Access Compliance Report

Public Rights-of-Way

Intersection ID: 28401	Main Street: WADE_ARDREY_RD	Cross Street: MARVIN_RD	Location: SE
ADA ID: 416427348D40	Ramp Type: BlendTrans1	Initial Pass/Fail: Pass	Overall Compliance: No
Codes/Mitigation Info/Possible Solution		Field Measurements/Component Compliance	
Severity Score: 0

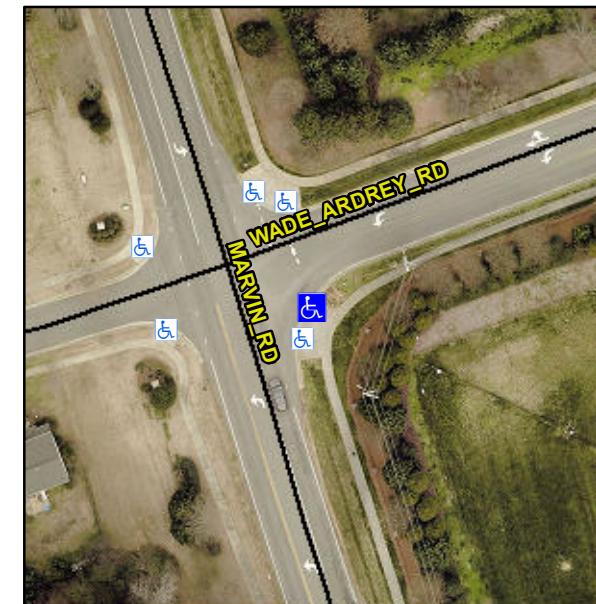
CURB GAP 1.0

Not Found, R304.2.2-Perp, R304.3.2-Para, R304.5.3

Remove & Replace Curb Ramp With Two New Directional Ramps or Equivalent.
